NSRP #0349
May 1992

P-52 Balloting of Hull
and
Mechanical Standards

Panel SP-6

PROJECT P-52
STATUS SUMMARY
5/28/92

TYPE IV
FIGURE 4

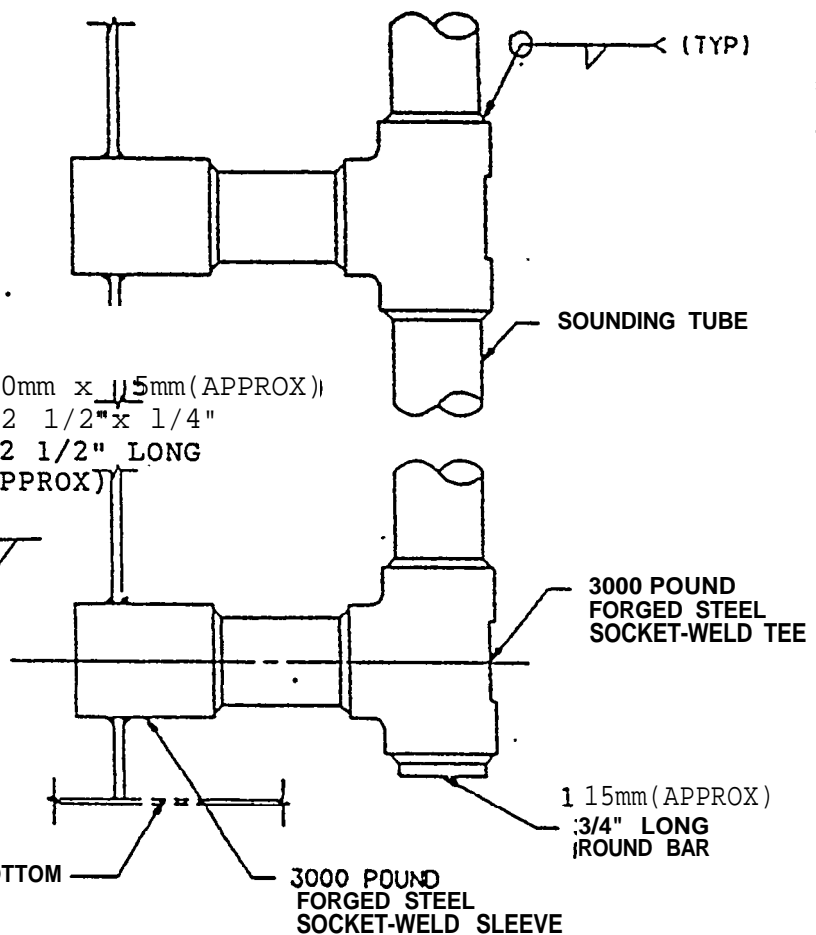
30. Fig.3 Type II - below the description of the 3000 psi socket-weld tee, propose change to designate "or equal" after description

Complied with - see Figure 4 Type IV (Figures and Types have been re-designated see comment 33)

FIGURE 5

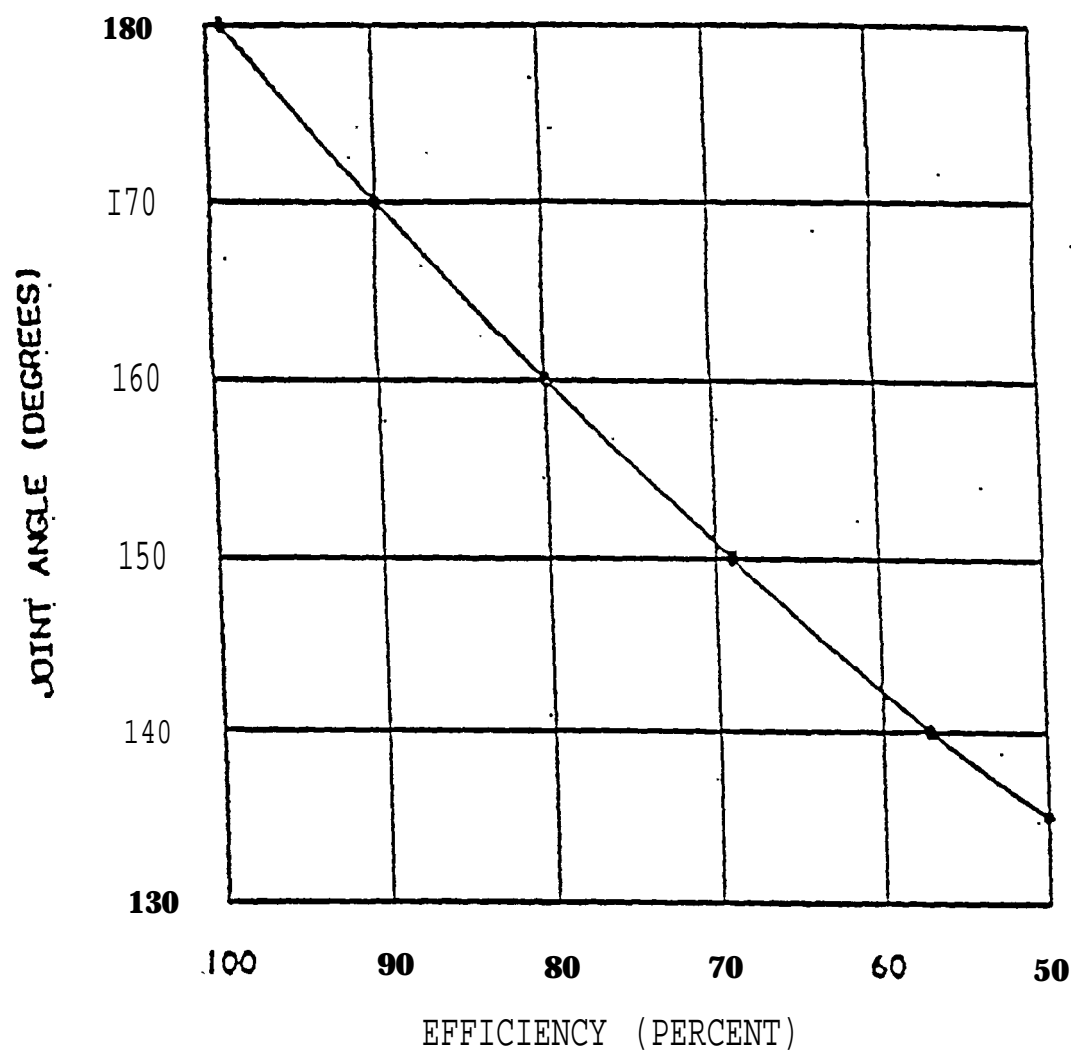
31. Figure 1 - What is Fig.1 intended to convey?.....	Universal Joint efficiency to be read in conjunction with Table 1.
32. Para 7.1.2.4 - Hyphenate three-spindle gear box - In addition; hyphenate "Reach-Rod" wherever noted in draft.	Concur

FIGURE 1. WATER TRAP FORD DIESEL EXHAUST

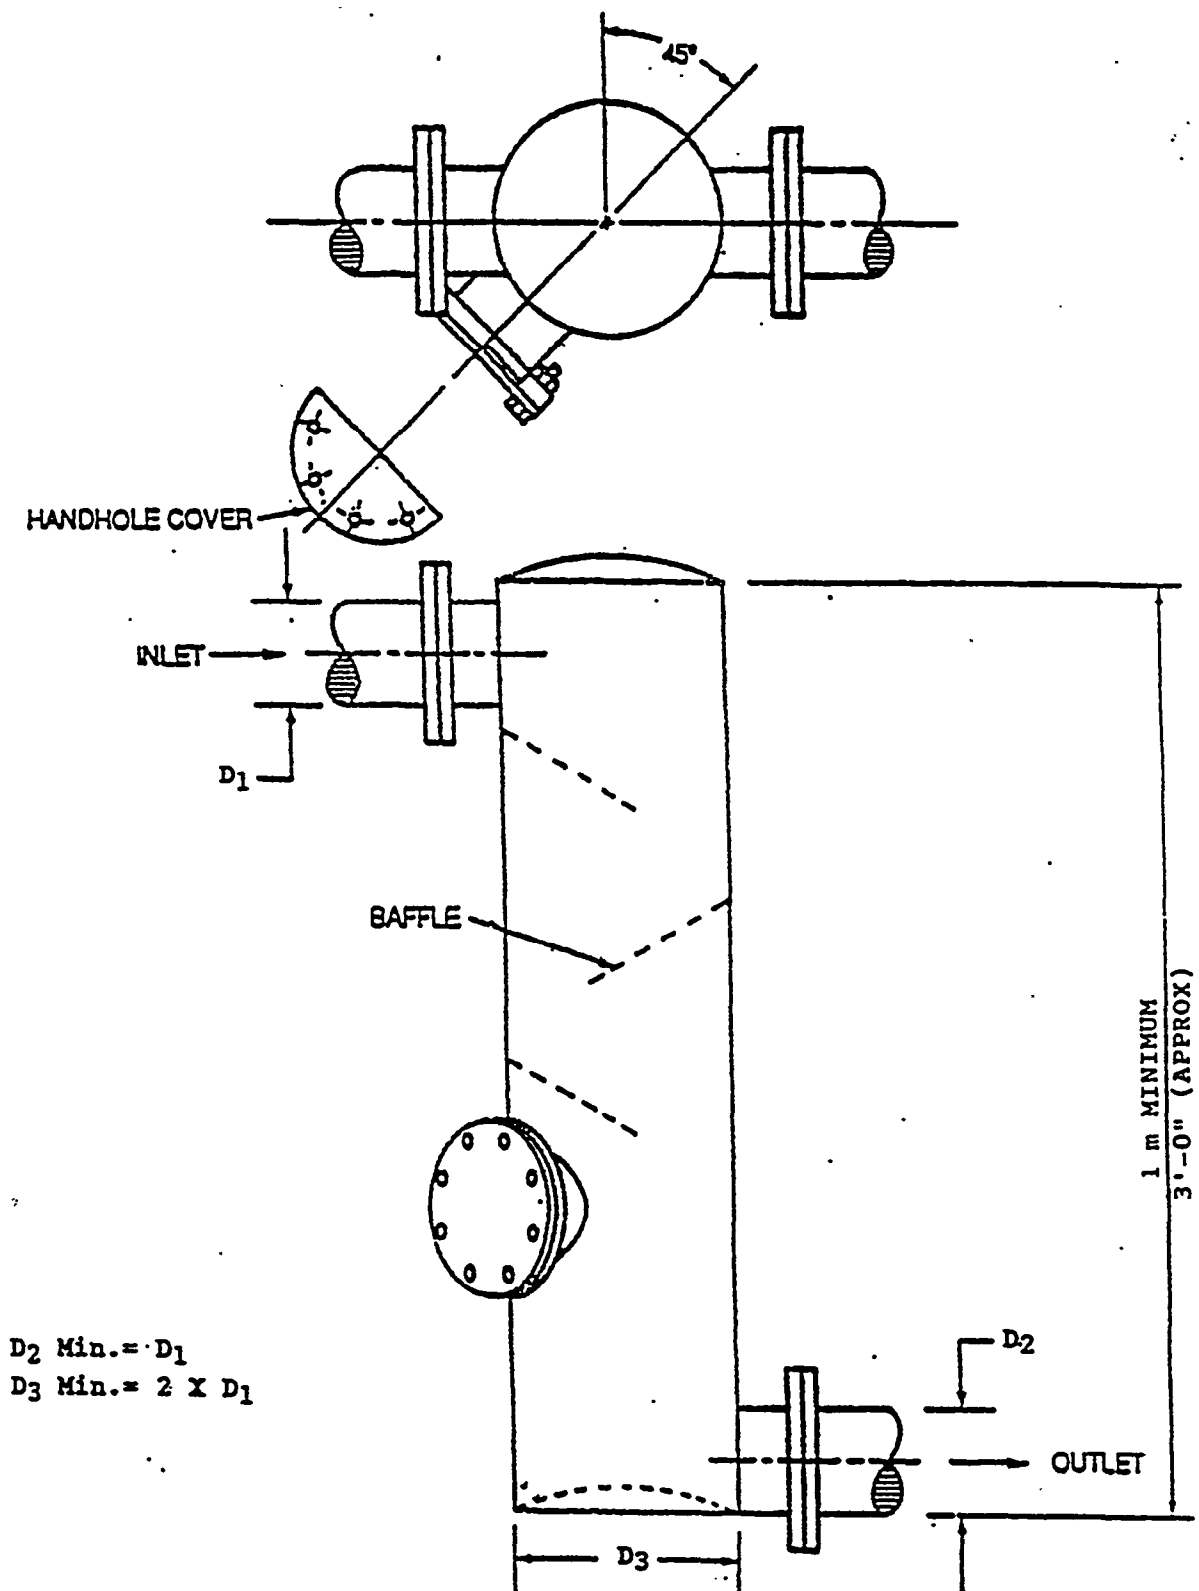
| 5. Fig. 1 -.There is no need to show 4" & 8" dimensions, since Para 5.3.2 indicates trap diameter equals twice the inlet dia. | Concur |

4. Fig.1 - (a) Delete handhole serves no purpose.

8. There is no need to show 4" (100mm) a 8" (200mm) on Fig-1. per para 5.3.2 the trap dia equals to twice the inlet dia...

| 33. Fig.1 - Correct. min. dimension to read "1 m minimum (3' approx)." | Concur - See Comment (6) |

FIGURE 1
LIGHT DUTY DAVIT
TYPE I

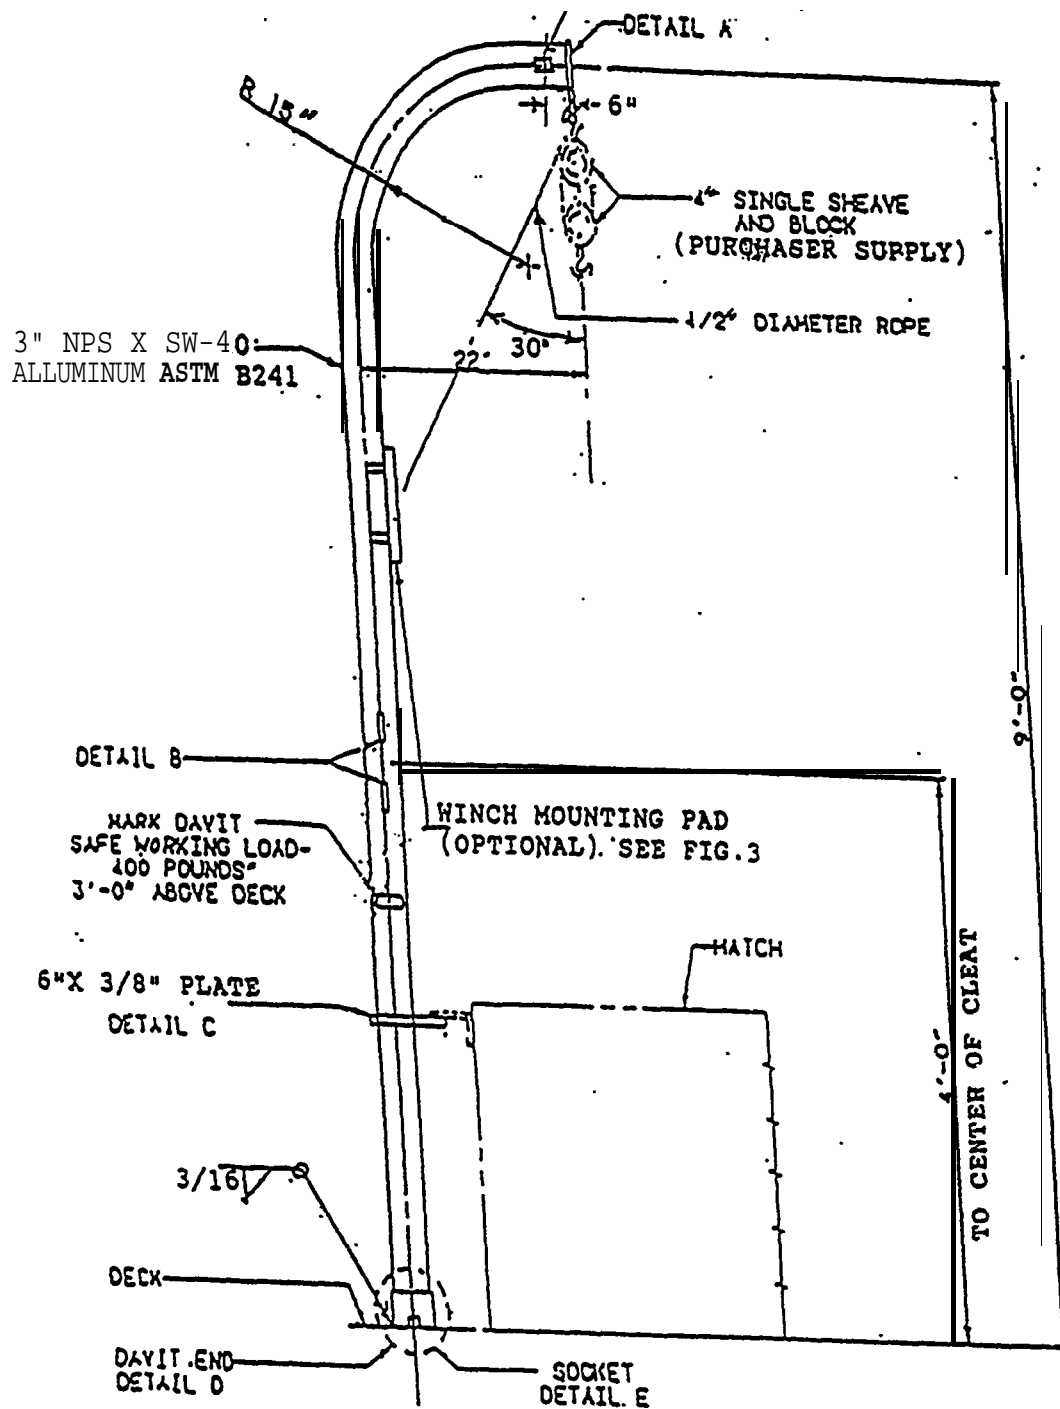
24. Figure 1 - Indicate whether rope sheaves & block are supplied with davit.

25. Indicate detail "B" as cleat in Fig. 1.

27. Add alternative pedestal support in lieu of hatch in Fig. 1.

28. Indicate detail C in Fig. 1. "where applicable" if used in conjunction with a hatch and add separate pedestal details.

44. Fig. 1 - Is the socket welded to the deck? If so, what is the weld? How is the socket protected when not in use?	Socket welded to deck. For details of weld, see detail E. Protection of socket left to the ship.

45. Fig. 1 - Det.C - If this is welded, how is it portable?	The hatch cover mounting plate is bolted to hatch cover - Also material has been identified in this detail.

FIGURE 2
HEAVY DUTY DAVIT TYPE II

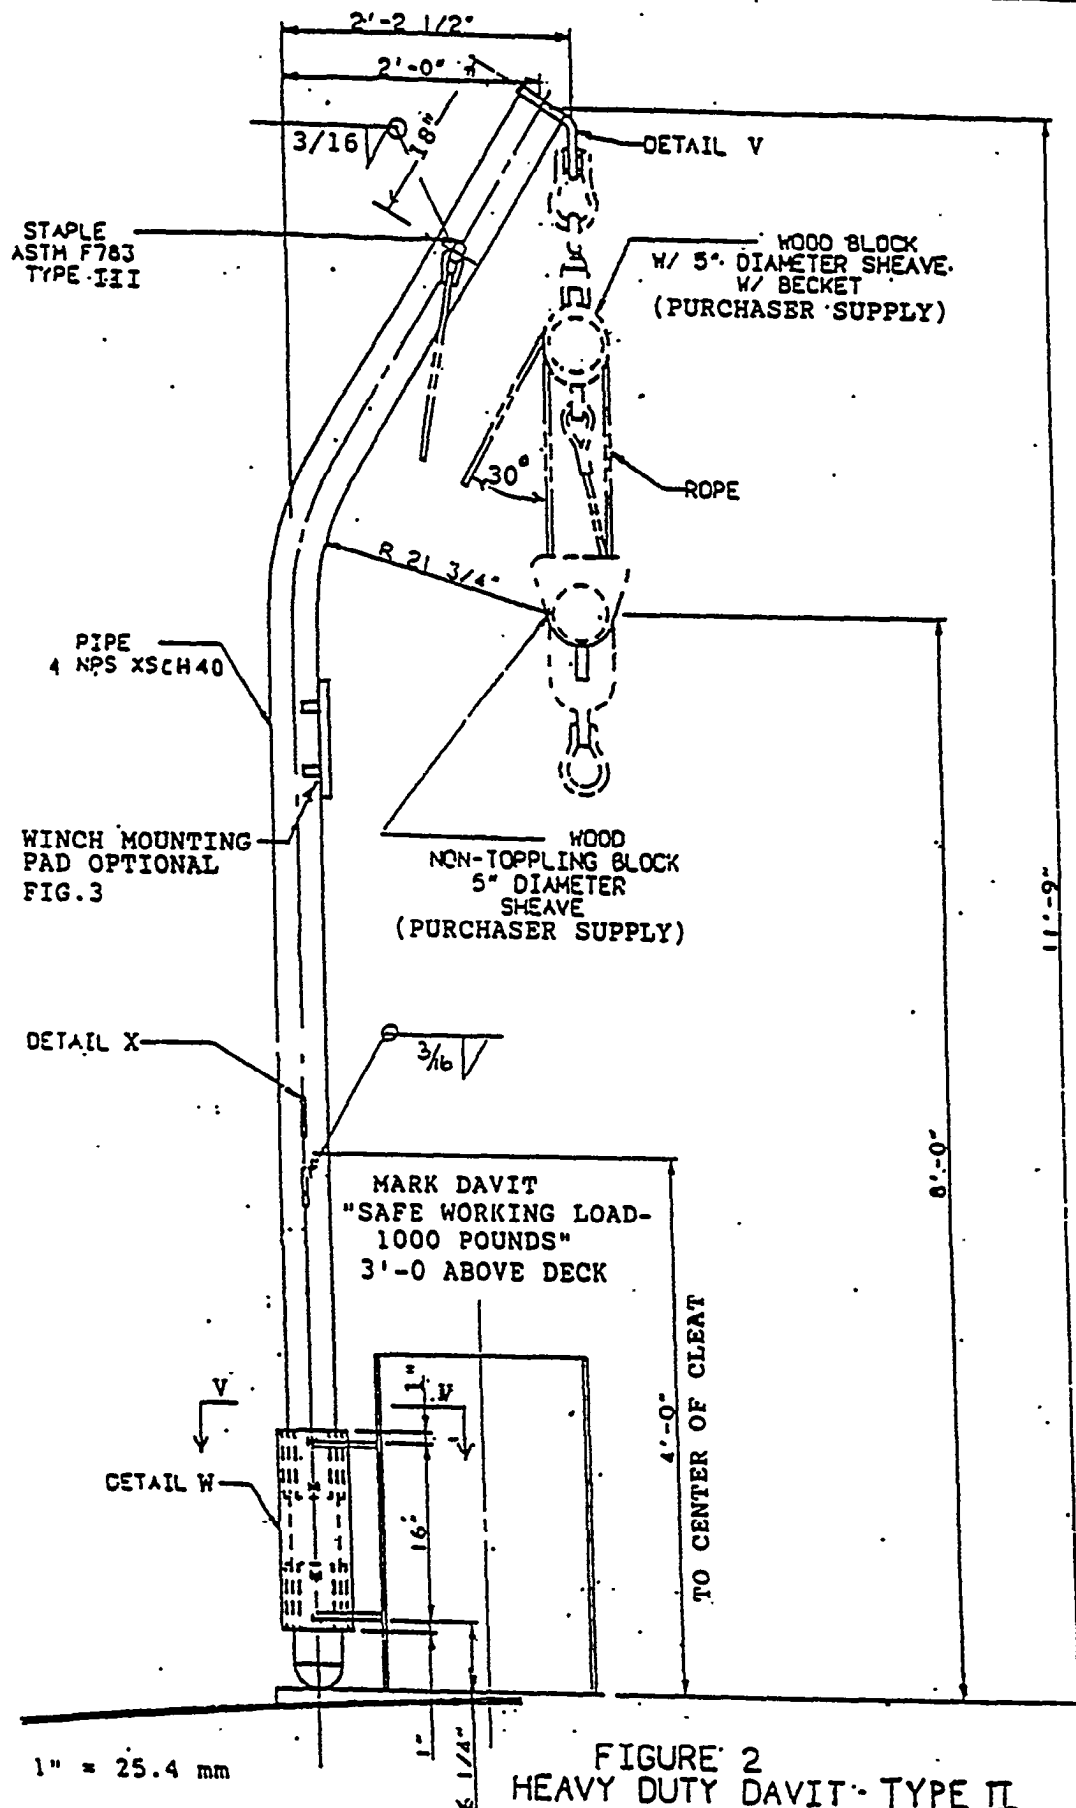
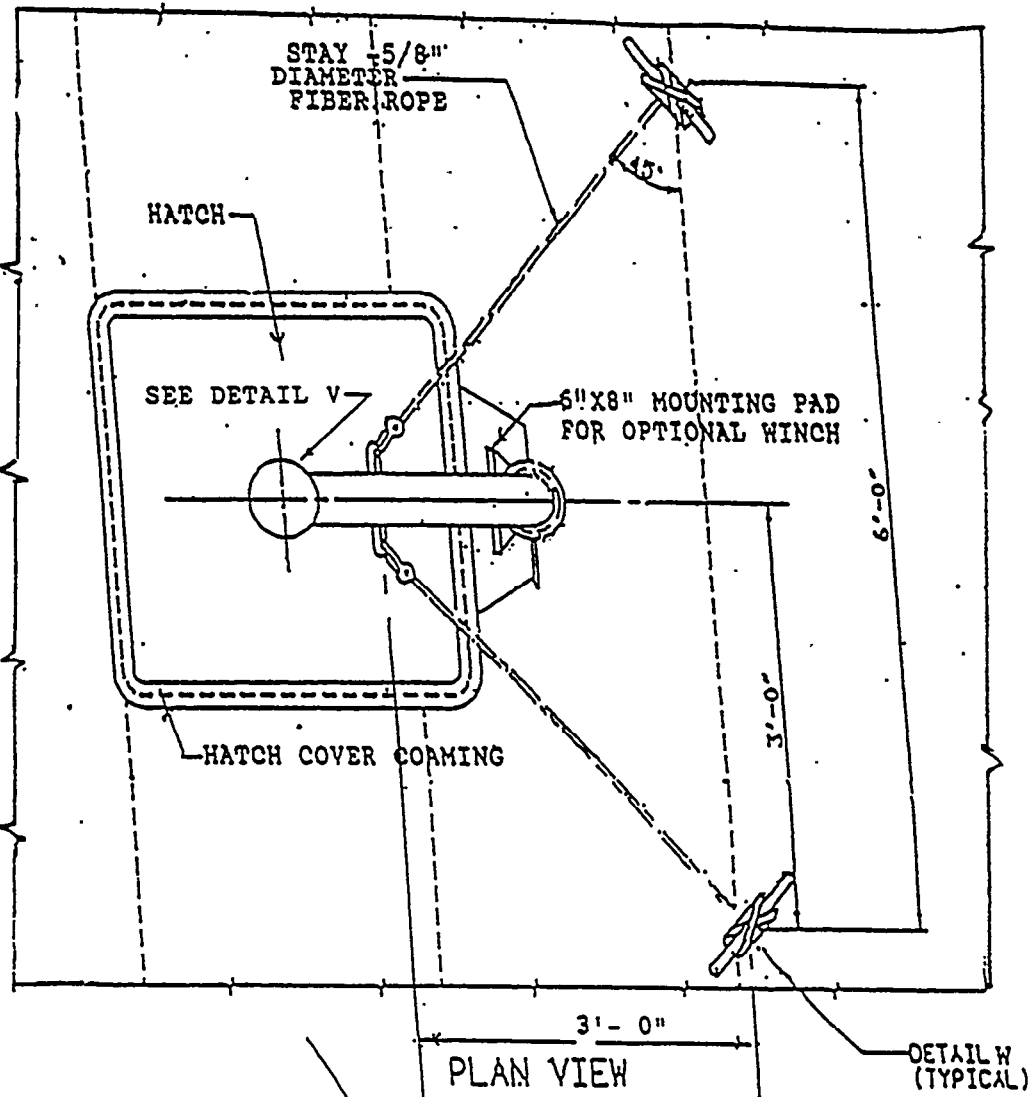
30. In Fig. 2 - Indicate SWL approximately 3 ft. above deck rather than above cleat as shown.	Complied with.
31. Fig. 2 - Indicate detail 'C' as cleat,.	Agree

32. Fig. 2 - Indicate what support for detail B is.	Not Required;
33. Fig. 2 - Indicate or detail base plate which davit rests on.	Disagree
34. Page 9 - "Plan view" - Indicate if rectangular item is davit base or what it is.	Clarified- it's a hatch coaming.

47. Fig. 2 - Comment (43) above applies to this figure.

48. Fig. 2 - Change 1/4" fillet weld to 1/8" to suit det. C.

20. Fig.2 - Det. Y Should be label led Det. w.	Concur
21.. Fig.2 - Remove Det.. Y Cleats and use std. dk. cleats for securing .	These Cleats are part of manu- facturers supply; hence the sketch.

22. Fig.2 - Dets X & Y are missing "typical" cm weld.	Concur - Revised
23. Fig.2 - Was winch pad sized far a specific winch or random choice? Specific is recommended along with identifying winch.	This is owner's choice of make & manufacture of winch. This is an optional item.
<u>E.T. Kinney (NAVSEA) (N)</u>

WRENCH/NOZZLE CLIP
DETAIL "A"

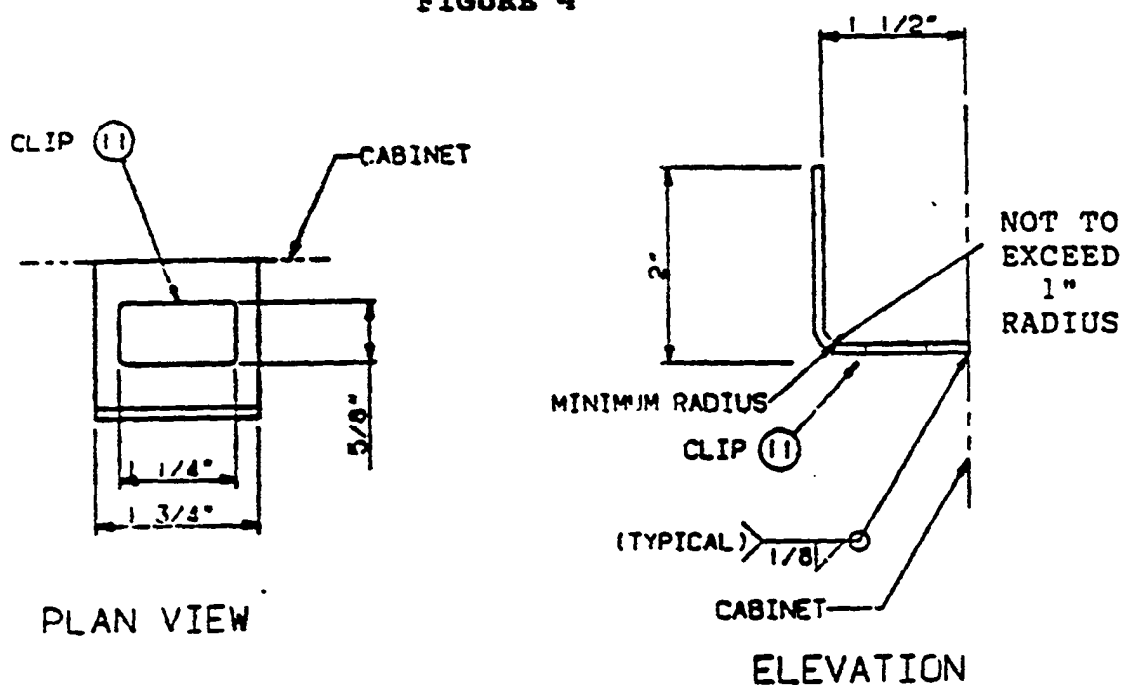
| 9. Page 9 - Section B-B- location for wrench not satisfactory. | Disagree - See Fig 5 detail "A" for arrgt. |

FIGURE 1

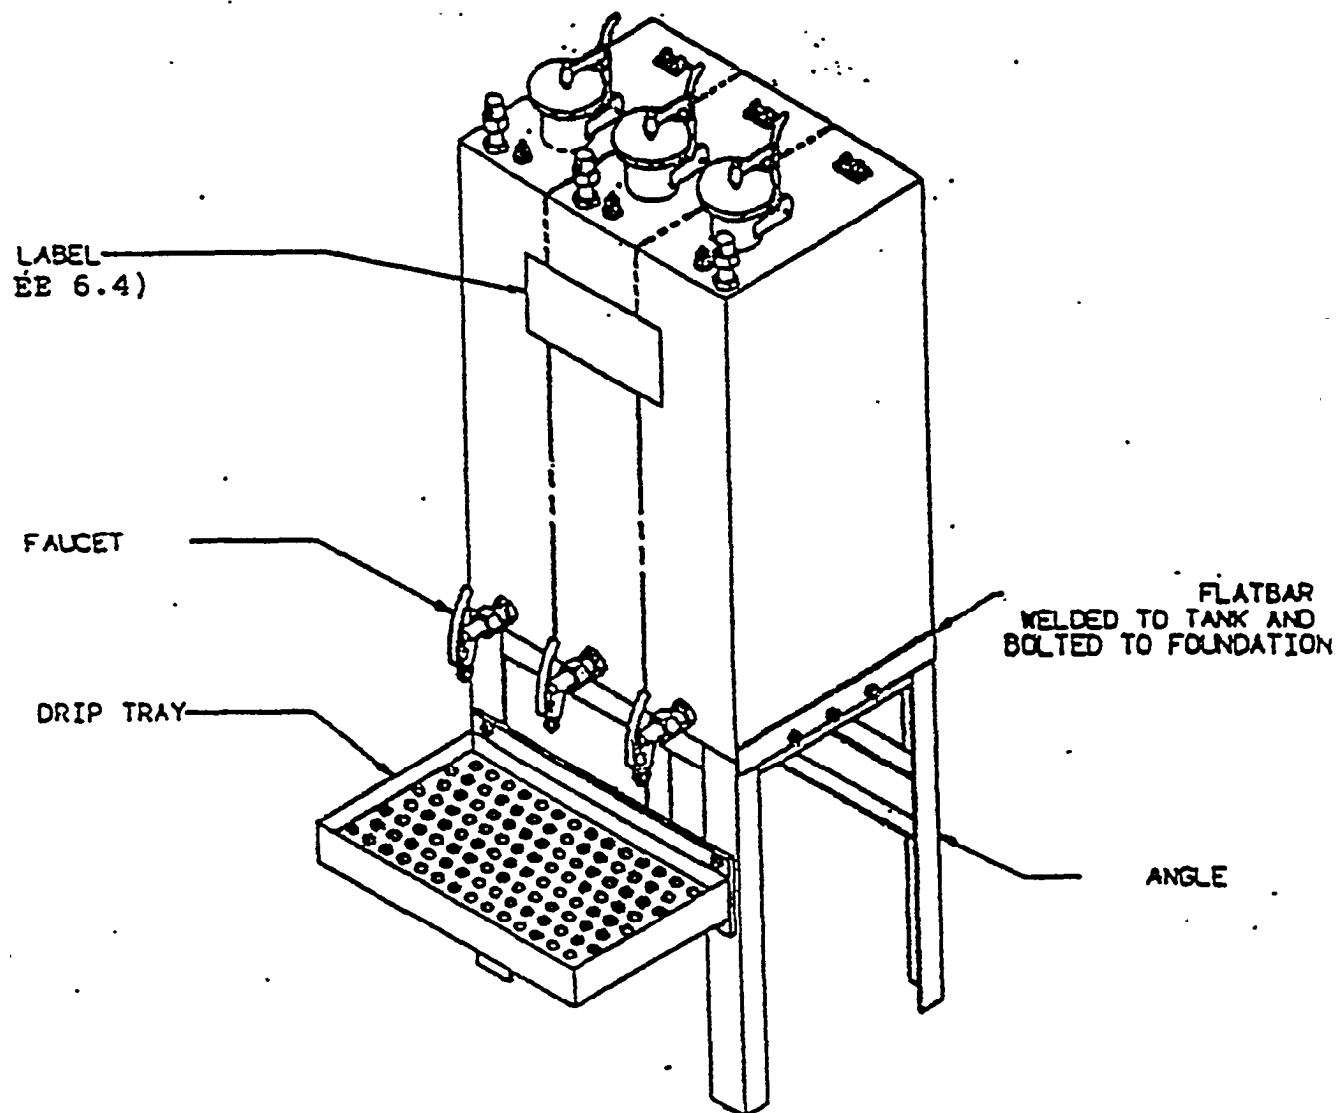
10. Fig. 1 & 2 should have title assigned to them.	Concur
11. Fig. 1 - Next to either top or bottom "A" (Detail A-A) insert (See Figure 2).....	Concur
12. Fig. 2 - If "A-A" Section is the title of this Figure Insert..	Non-Concur - Figure No.'s have been changed and comment (10) has been adhered to.
